LIST OF CORRECTIONS to the notification texts OTIF/RID/NOT/2017

Figure 5.2.1.9.2

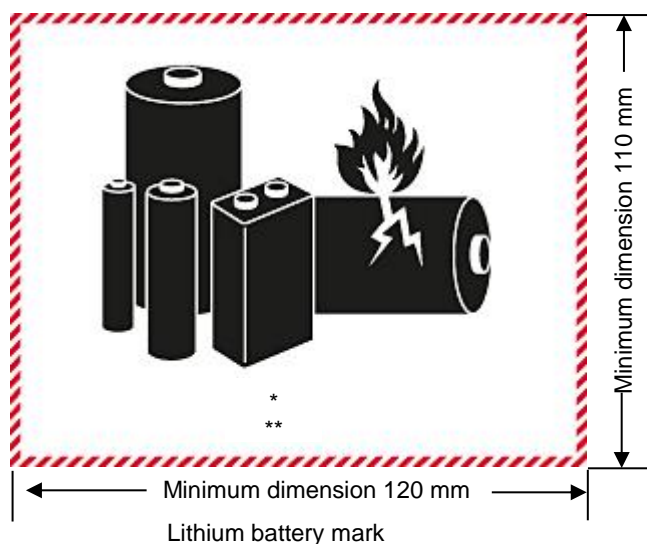
5.2.1 Add a new **5.2.1.9** to read as follows:

5.2.1.9.1 Packages containing lithium cells or batteries prepared in accordance with special provision 188 shall be marked as shown in Figure 5.2.1.9.2.

5.2.1.9.2 The mark shall indicate the UN number preceded by the letters "UN", i.e. "UN 3090" for lithium metal cells or batteries or "UN 3480" for lithium ion cells or batteries. Where the lithium cells or batteries are contained in, or packed with, equipment, the UN number preceded by the letters "UN", i.e. "UN 3091" or "UN 3481" as appropriate shall be indicated. Where a package contains lithium cells or batteries assigned to different UN numbers, all applicable UN numbers shall be indicated on one or more marks.

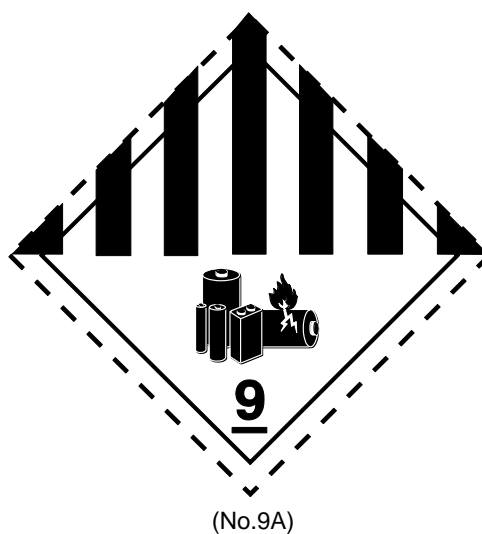
At the beginning of the last paragraph, insert:

"Except for label model No. 9A,".
